**EAST GOSHEN TOWNSHIP
PLANNING COMMISSION
Meeting Agenda
Wednesday, July 1, 2020
VIA Telephone / Video Conference
7:00 PM**

Date: 6/25/2020
To: Planning Commission
From: Mark Gordon, Township Zoning Officer *mlg*
Re: Synthes USA / JABIL / Land Development Application

**RE: Jabil Finishing Plant Expansion, 1303 Goshen Parkway
Preliminary/Final Land Development Plan – 2nd Submission**

RE: 1303 Goshen Parkway – Preliminary / Final Land Development
Jabil Finishing Plant Expansion
1303 Goshen Parkway, West Chester, PA 19380
Mainstay Project Number: 19360
Pennoni / EGT Reference: EGOST00131

C0.11

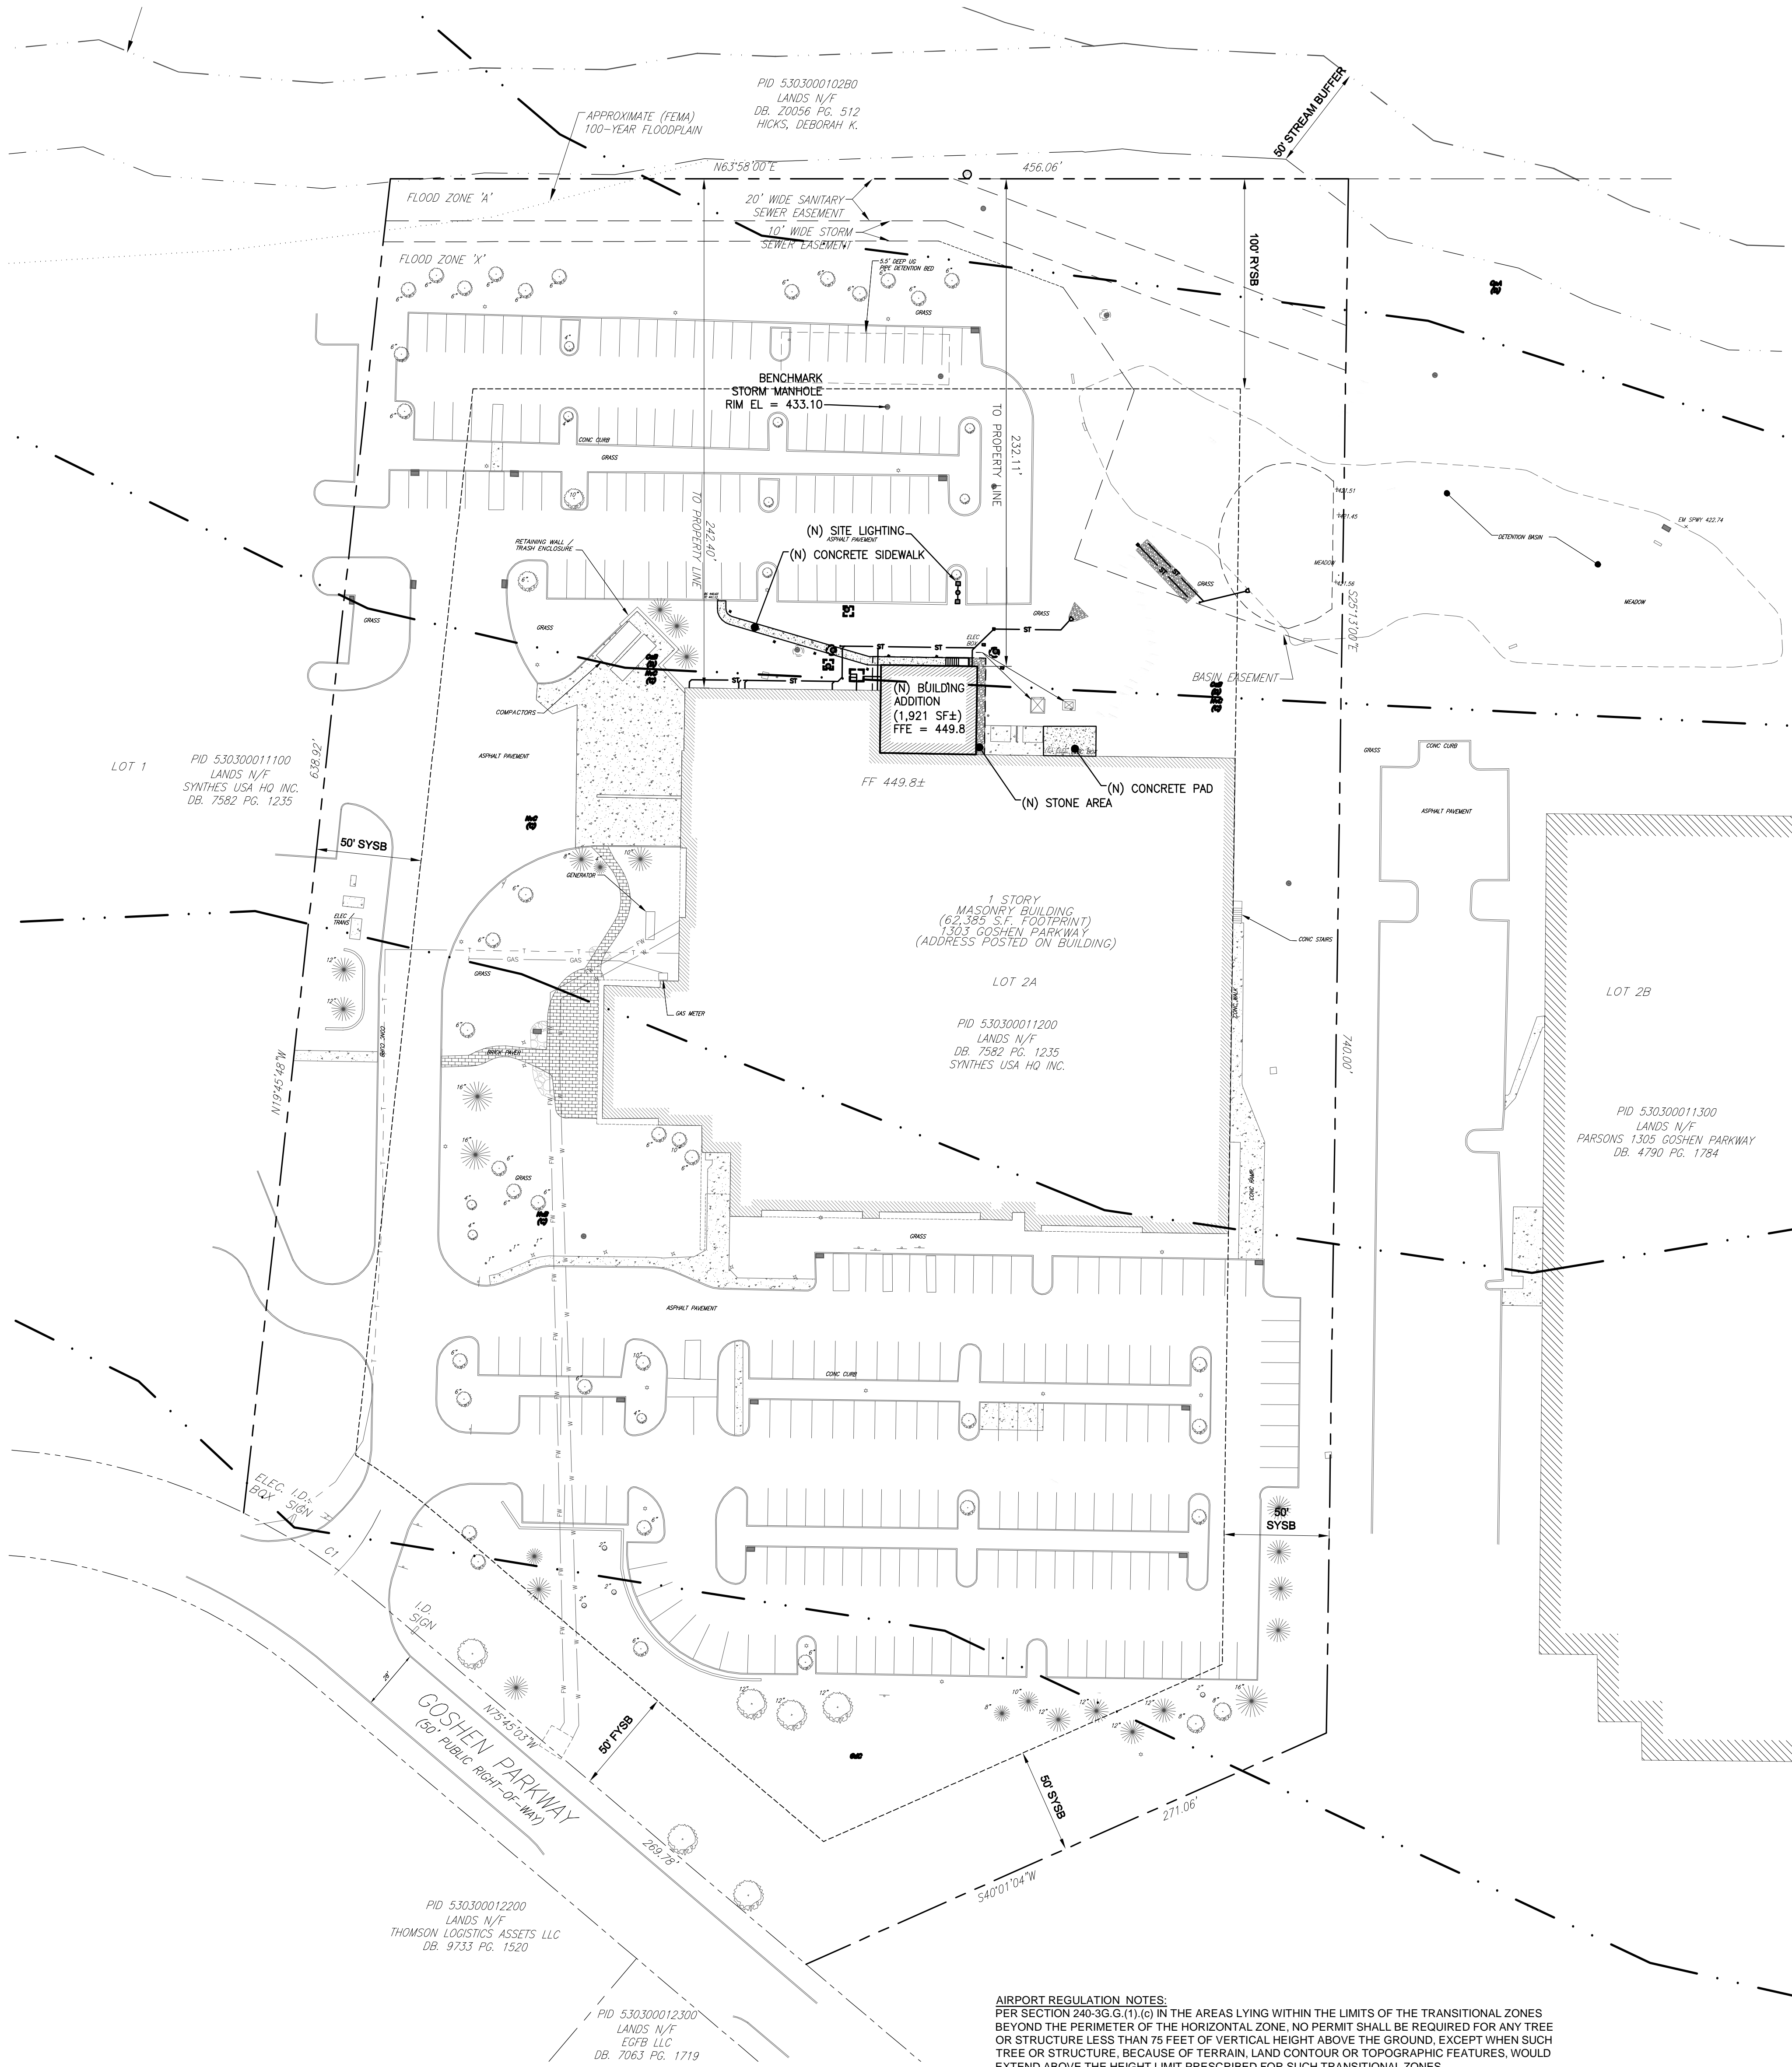
3. While not identified on Sheet C0.11 (Conditional Use Plan), the October 17, 2017 Township Board of Supervisors meeting minutes indicate that conditional use approval was granted to increase the impervious coverage on the property to sixty percent (60%), with six conditions of approval (we note that the Zoning Summary table Sheet C0.12-Land Development Plan indicates that the maximum impervious coverage is proposed to increase from 55 percent to approximately 56 percent). Prior to granting final plan approval, the Township should verify that all applicable conditions of approval are incorporated into the final plan, the details of which should be identified on the plan.

Drawing No.:
C0.12

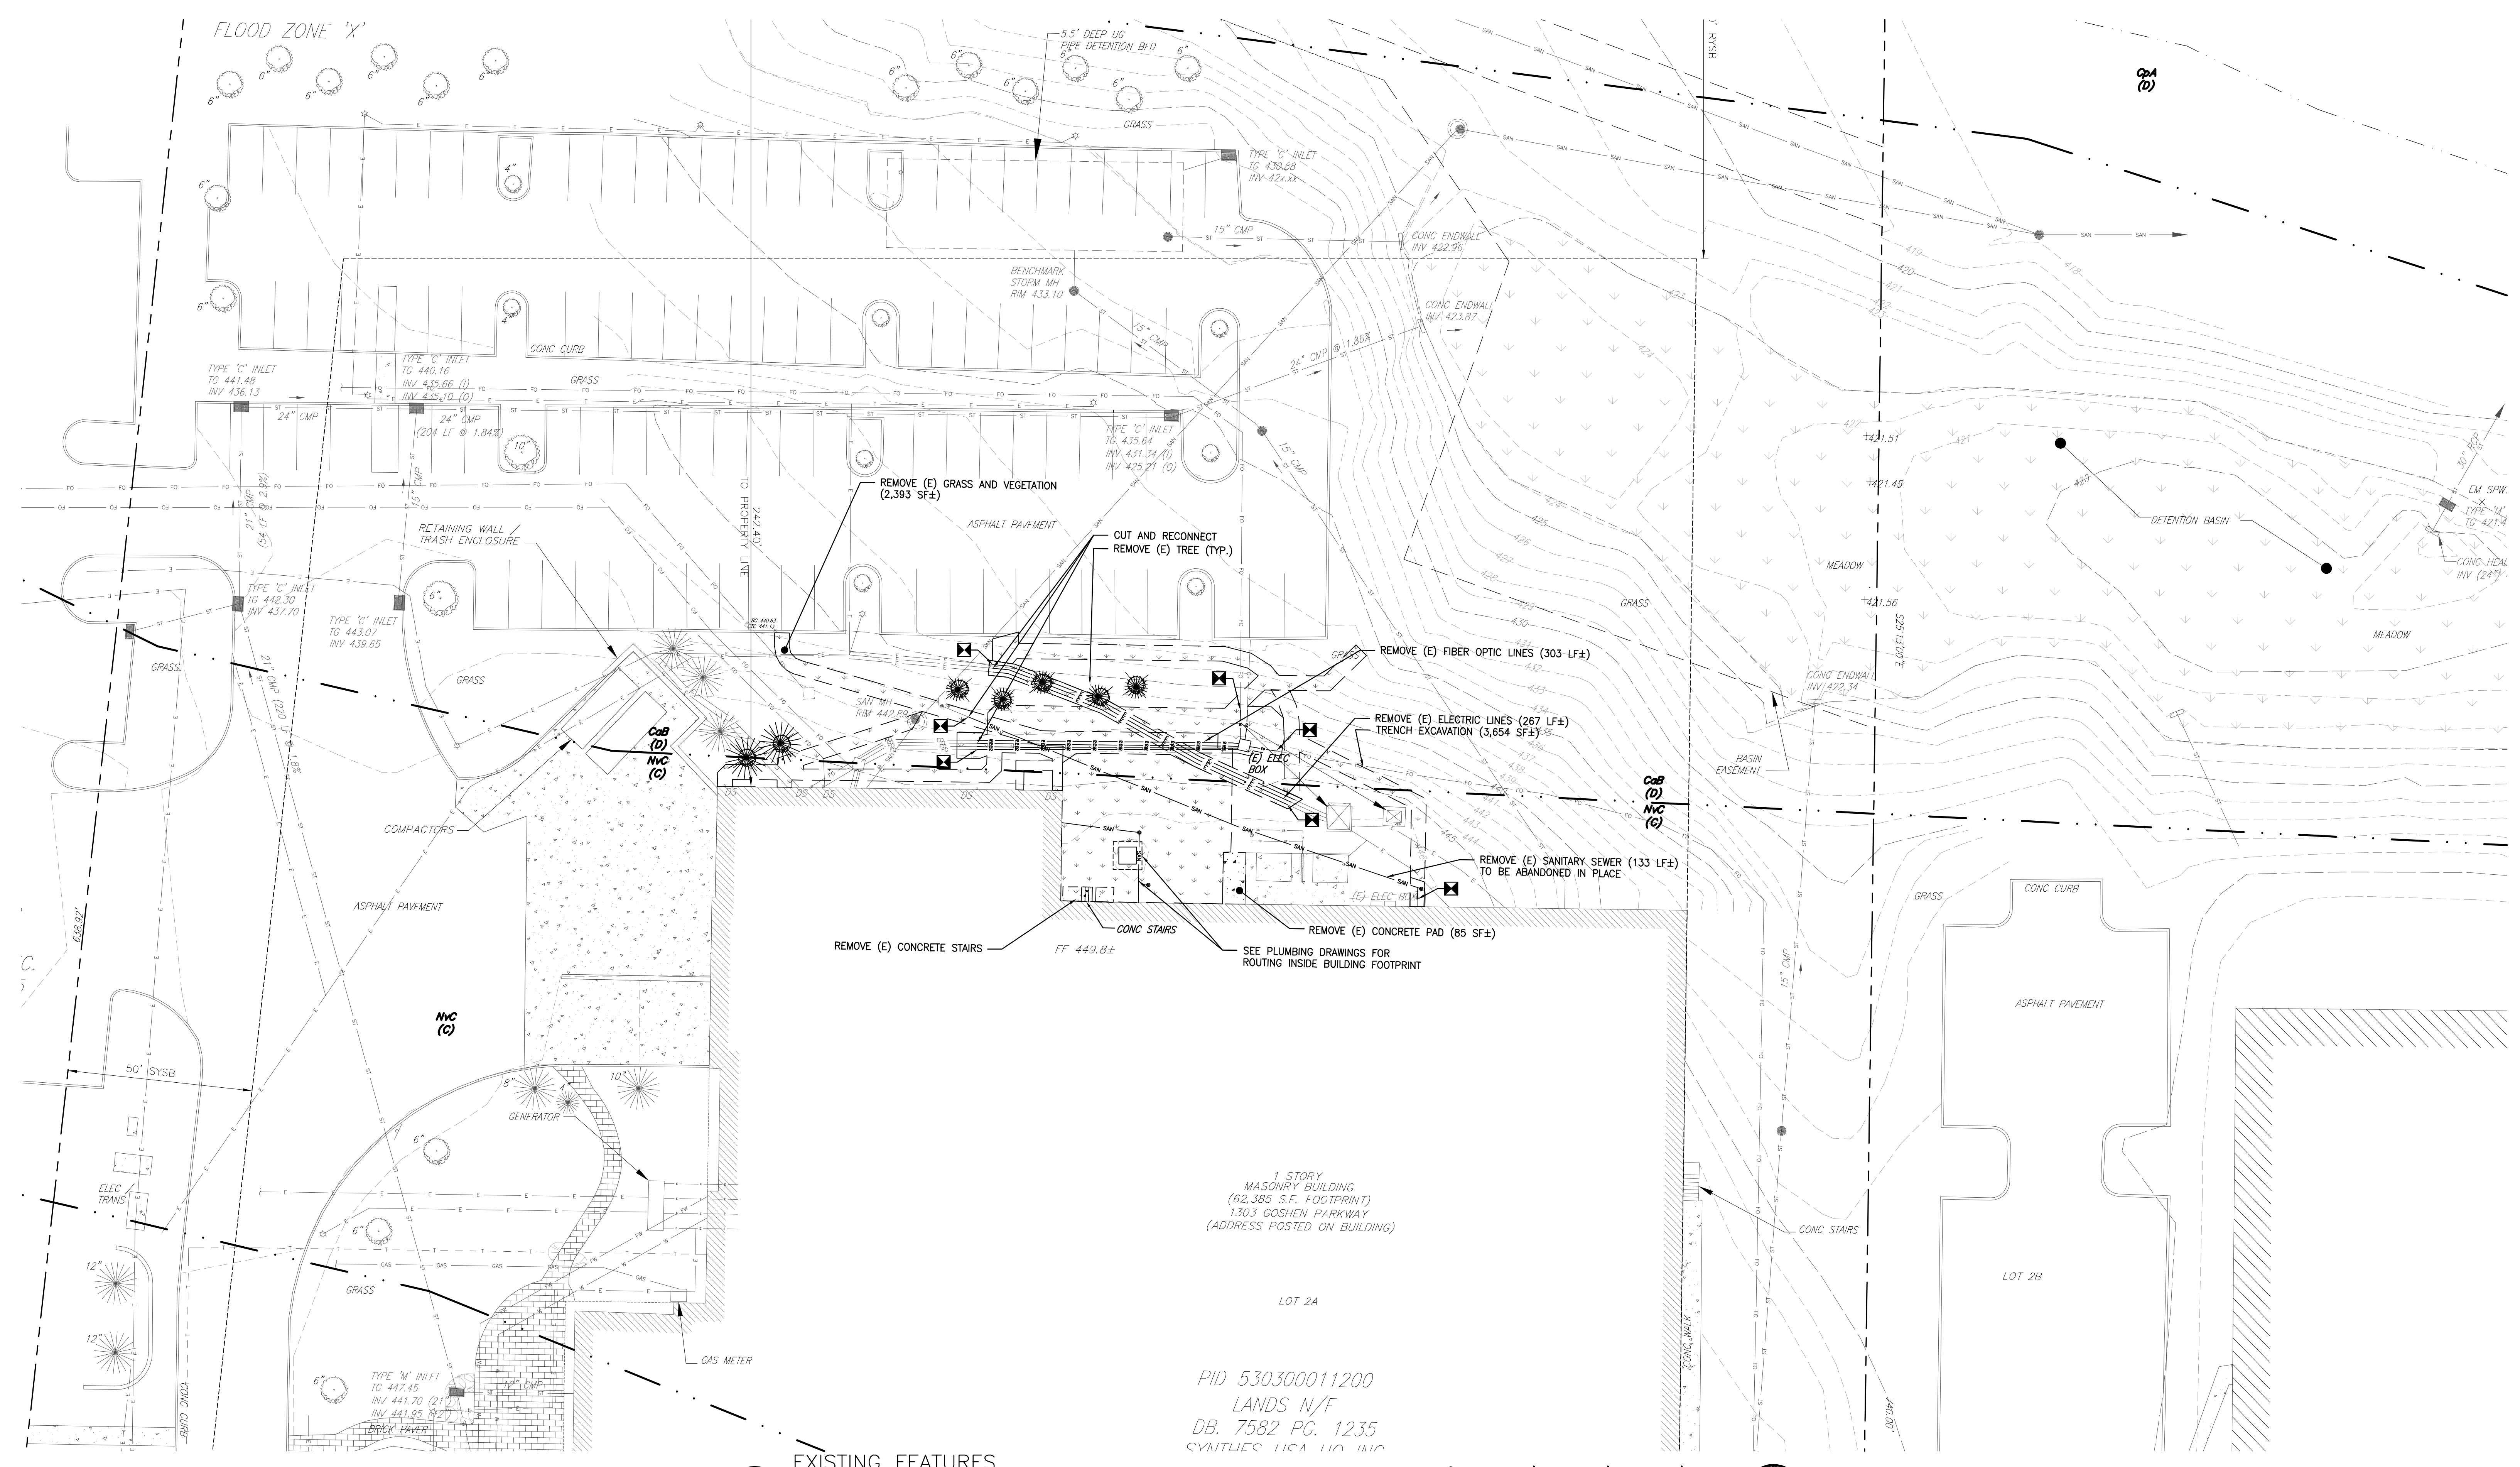
27. We recommend the Conditional Use approval be noted on the plans and referenced below the Zoning Summary table (Sheet C0.12) regarding the impervious coverage.

Resolved. The Conditional Use approval as been added to the plans below the Zoning Summary table.

The Conditional Use Approval as stated by East Goshen Township has been added adjacent to the Zoning Summary on C0.12.
